**CITY OF DELAWARE
PLANNING COMMISSION MEETING
COUNCIL CHAMBERS
1 SOUTH SANDUSKY STREET
6:30 P.M.**

PLANNING COMMISSION AGENDA ITEM REPORT

PLANNING COMMISSION / STAFF REPORT

2021-3843: A request by Addison Properties for approval of a Rezoning Amendment from A-1 (Agricultural District), R-3 (One-Family Residential District) and B-4 (General Business District) to A-1, R-3 & B-4 PMU (Agricultural District, One-Family Residential District and General Business District with a Planned Mixed Use Overlay District) for Addison Farms on approximately 272.698 acres located west of US 23 and east of Smith Park.

Example of section where multi-use path deviates from location in right-of-way. Also it appears to show the allocated right-of-way in the stream buffer south of Merrick Parkway.

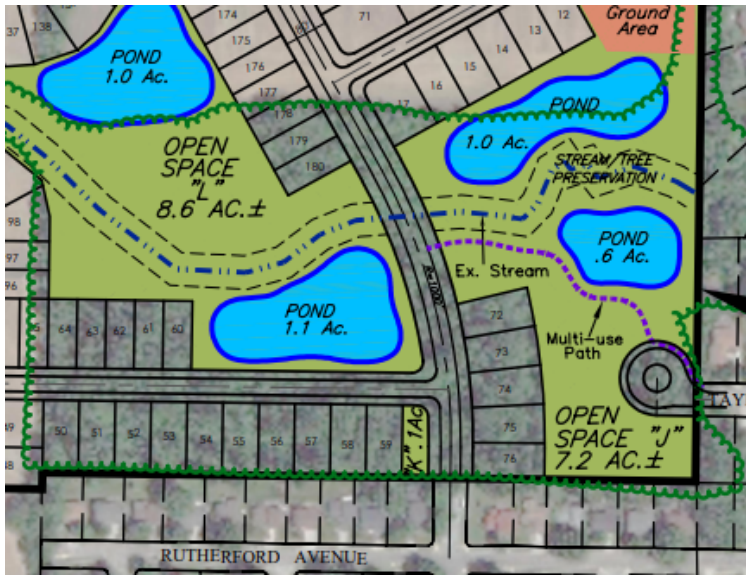
3. Is it permissible to have right-of-way in the stream corridor? (See south of Merrick Parkway, above.) Is there any risk to this protective buffer by having the right-of-way in that area, and the roadway so close?
4. As planned, can the roadways be installed without disrupting the vegetative buffer around the stream corridor?
5. During what phase is a pedestrian crossing to Smith Park added? Is it going to be an over-, above-, or at-grade crossing?
6. How much tree canopy is preserved in the plan?

Example of ponds to be added to wooded area in sub areas C and D.

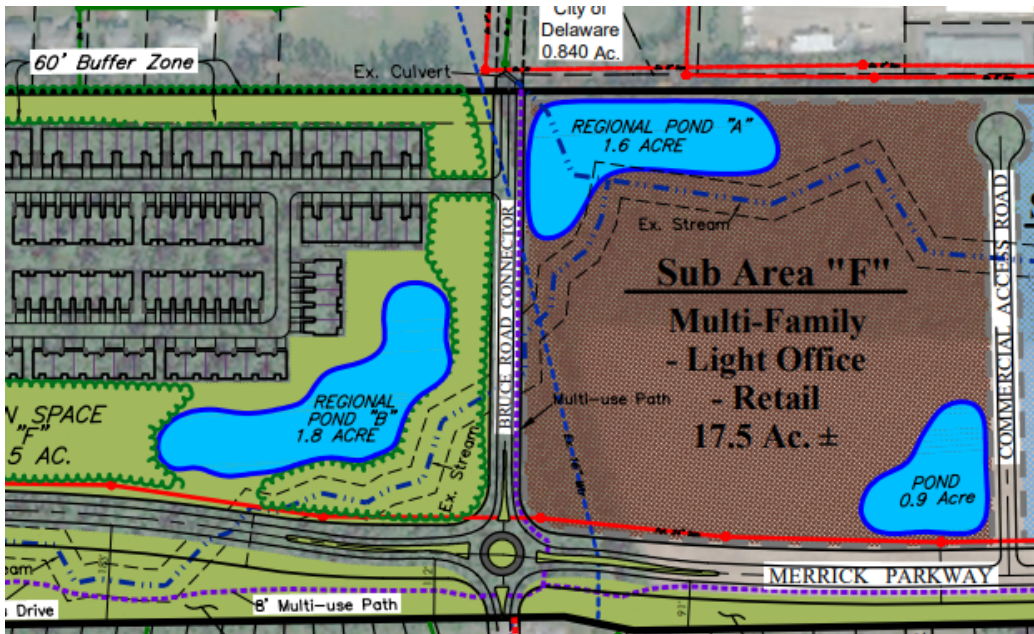
7. Why are the retention ponds in the treed areas (especially in sub areas C, D, E, and F)?

Examples of ponds to be added to wooded areas of sub area E and F (the 1.8 acre and 1.6 acre ponds are in tree-covered areas).

Example of measurement marker desired shown in orange: narrowest point from property boundary to right-of-way.

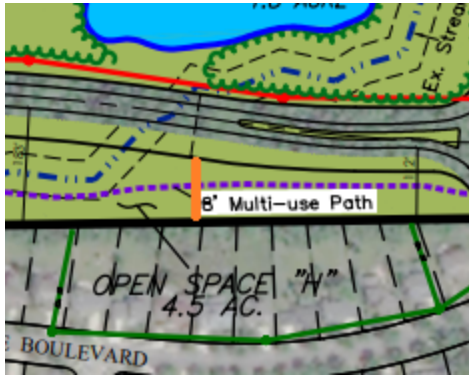
9. What is the distance as measured from the back of each existing property to the Merrick Parkway southern right-of-way boundary? Please provide measurements at the narrowest point. Please include all properties south of sub areas E, F, and G.
